1CAN111401

November 21, 2014

SUBJECT: License Amendment Request
Update the Reactor Coolant System Pressure and Temperature and the
Low Temperature Overpressure Protection System Limits
Arkansas Nuclear One, Unit 1
Docket No. 50-313
License No. DPR-51

Proposed Technical Specification and Bases Changes (mark-up)

FIGURE 3.4.3-1
RCS Heatup Limitations to 5434 EFPY

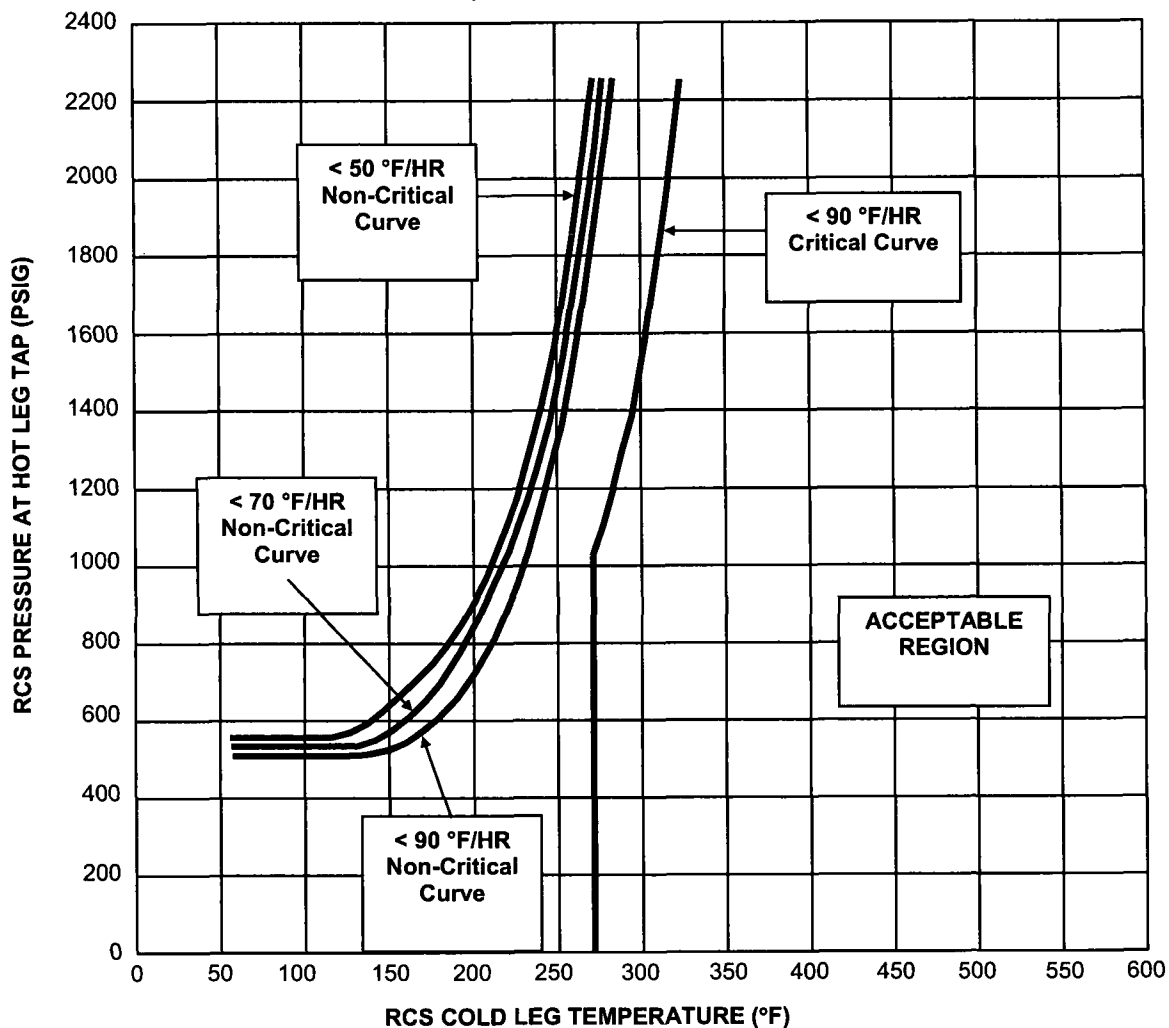
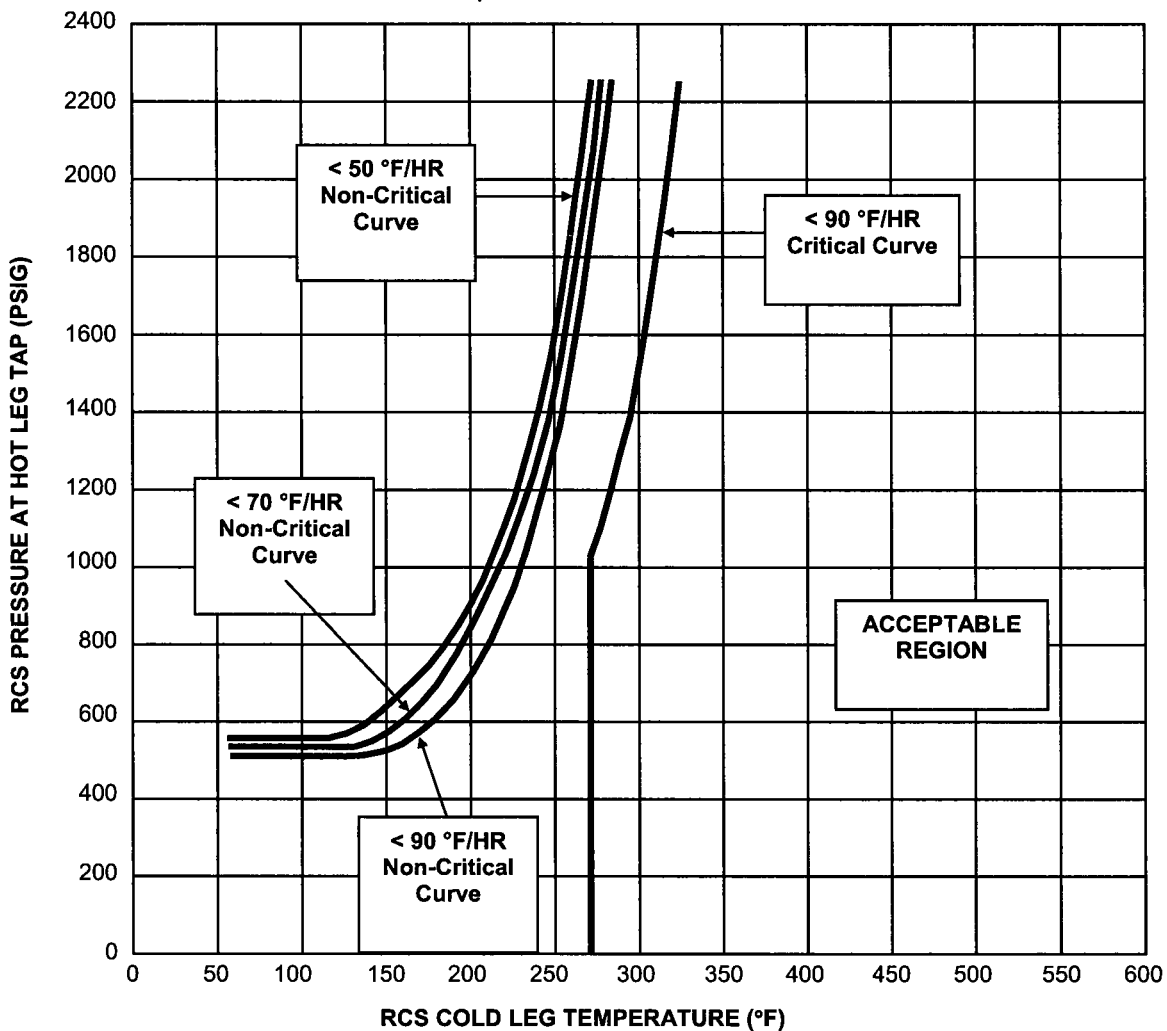
- TS Section 3.4.3 ("RCS Pressure and Temperature (P/T) Limits") is being revised to incorporate updated figures for P/T curves and reactor coolant pump restrictions. These figures have been recalculated to account for 54 EFPYs of plant operation.
- TS 3.4.9, "Pressurizer"; TS 3.4.10, "Pressurizer Safety Valves"; and TS 3.4.11, "Low Temperature Overpressure Protection (LTOP) System" are being revised to account for 54 EFPYs of operation. The changes include the electromatic relief valve lift setpoint being changed from 460 pounds per square inch – gauge (psig) to 553.8 psig. The enable temperature for this valve is being revised from 262 °F to 259 °F. These changes are as a result of the revised LTOP analyses and are consistent with the new P/T limits. Instrument uncertainty has not been included in these values.

<u>RCS TEMP</u>	<u>H/U RATE</u>
$60 \text{ }^\circ\text{F} < T \leq 84 \text{ }^\circ\text{F}$	$\leq 15 \text{ }^\circ\text{F/HR}$
$T \geq 84 \text{ }^\circ\text{F}$	As allowed by applicable curve

FIGURE 3.4.3-1
RCS Heatup Limitations to 54 EFPY

<u>RCS TEMP</u>	<u>H/U RATE</u>
T < 84 °F	≤ 15 °F/HR
T ≥ 84 °F	As allowed by applicable curve

FIGURE 3.4.3-2
RCS Cooldown Limits to 5434 EFPY

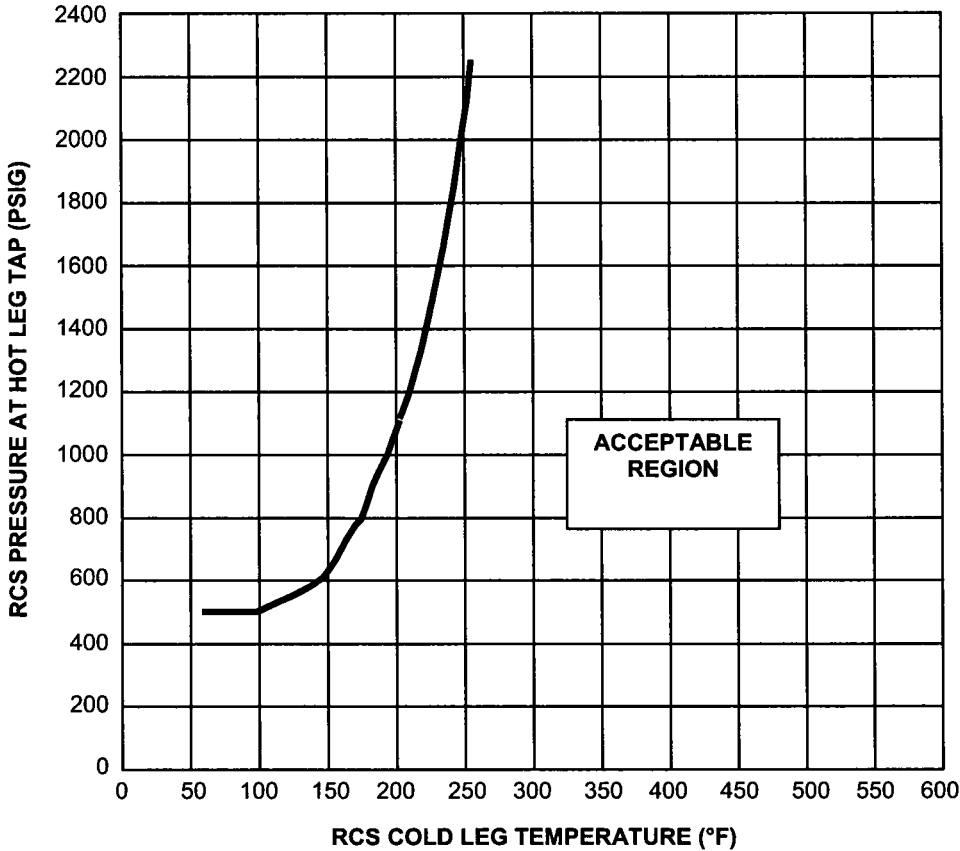
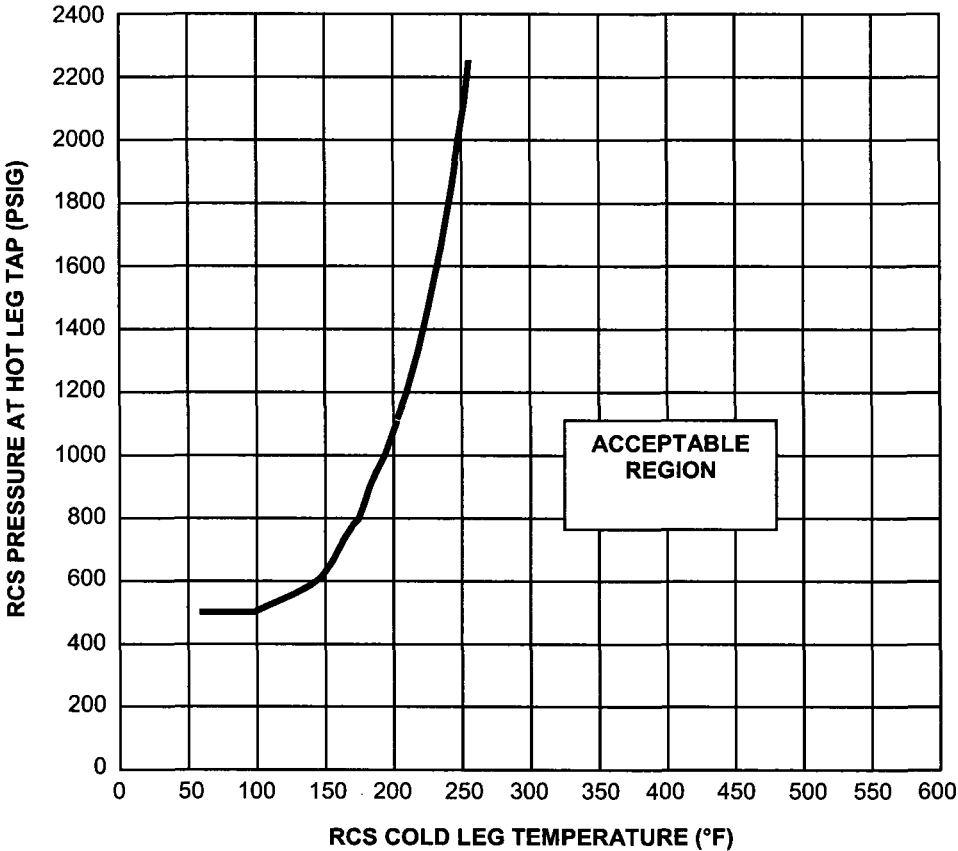
<u>RCS TEMP</u>	<u>C/D RATE</u>	<u>STEP CHANGE</u>
T ≥ 280 °F	100 °F/HR	≤ 50 °F in any 1/2 HR
280 °F > T ≥ 150 °F	50 °F/HR (Note 5)	≤ 25 °F in any 1/2 HR
T < 150 °F	25 °F/HR	≤ 25 °F in any 1 HR

5. If RCPs are operated < 200 °F, then the RCS cooldown rate from 150 °F ≤ T ≤ 180 °F is reduced to 30 °F in 15 hours.

FIGURE 3.4.3-2
RCS Cooldown Limits to 54 EFPY

<u>RCS TEMP</u>	<u>C/D RATE</u>	<u>STEP CHANGE</u>
T ≥ 280 °F	100 °F/HR	≤ 50 °F in any 1/2 HR
280 °F > T ≥ 150 °F	50 °F/HR	≤ 25 °F in any 1/2 HR
T < 150 °F	25 °F/HR	≤ 25 °F in any 1 HR

FIGURE 3.4.3-3
RCS Inservice Hydrostatic Test H/U & C/D Limits to 5434 EFPY

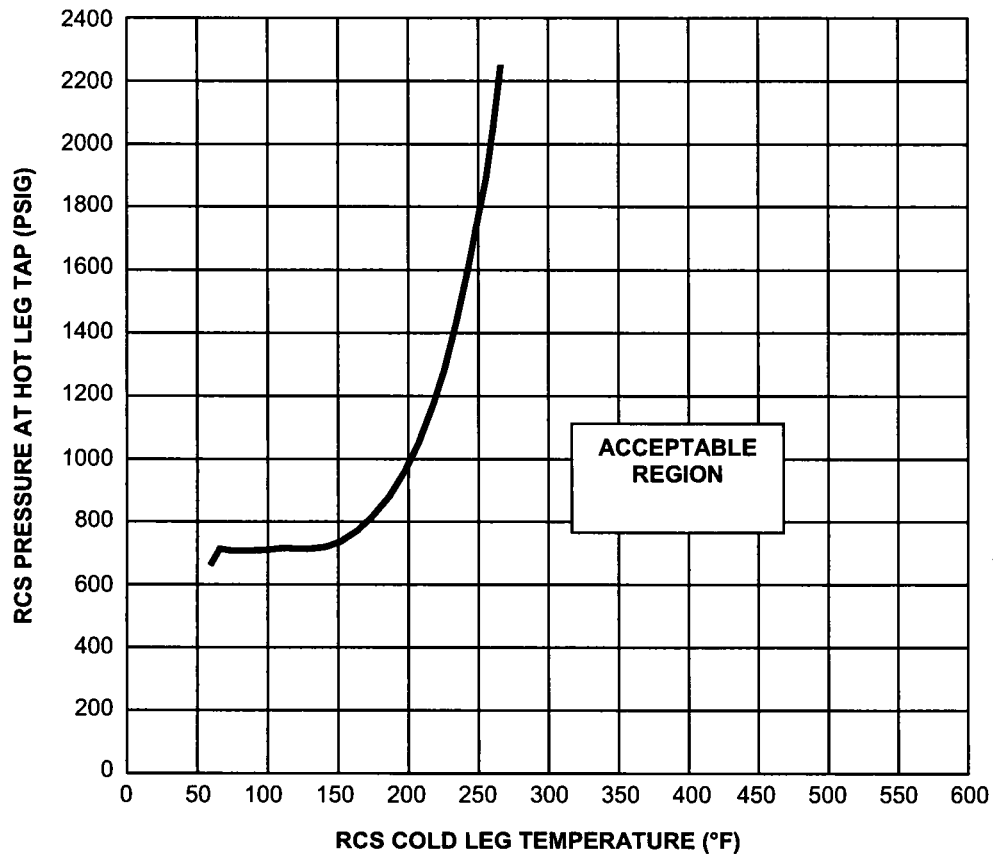
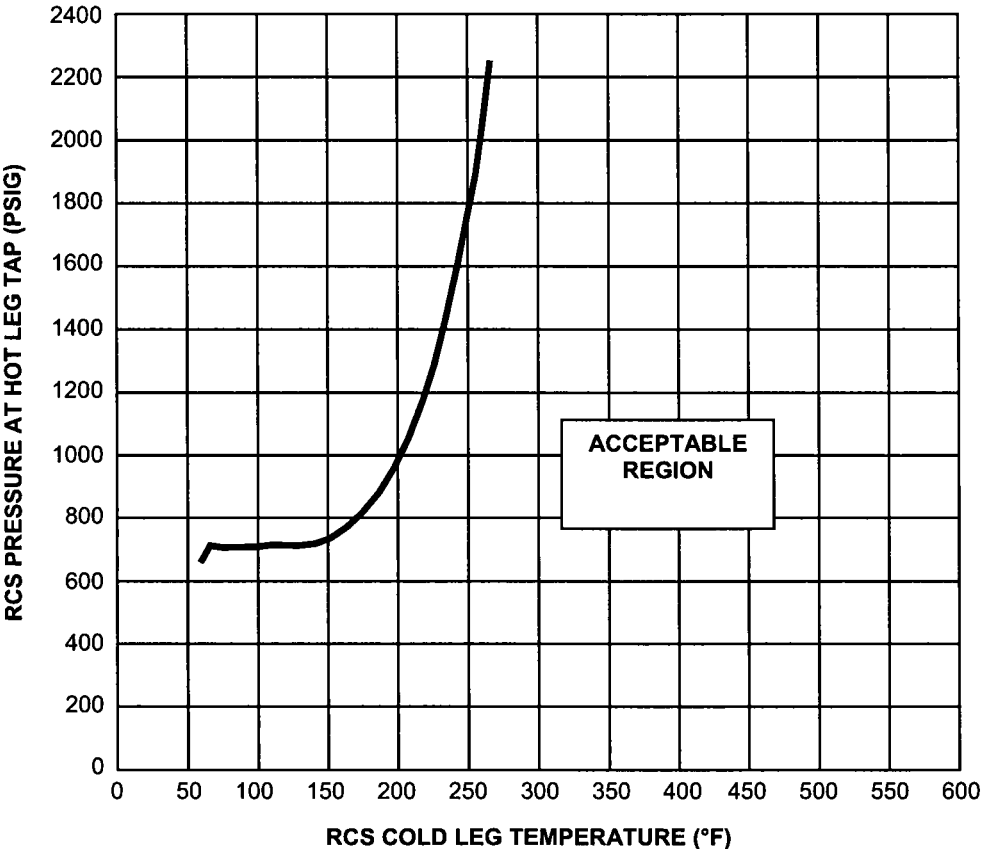
1. This curve is not adjusted for instrument error and shall not be used for operation.
2. All Notes on Figure 3.4.3-1 are applicable for heatups. This curve is based on a heatup rate of < 90 °F/HR.
3. All Notes on Figure 3.4.3-2 are applicable for cooldowns.

FIGURE 3.4.3-3
RCS Inservice Hydrostatic Test H/U & C/D Limits to 54 EFPY

- 1. This curve is not adjusted for instrument error and shall not be used for operation.
- 2. All Notes on Figure 3.4.3-1 are applicable for heatups. This curve is based on a heatup rate of < 90 °F/HR.
- 3. All Notes on Figure 3.4.3-2 are applicable for cooldowns.
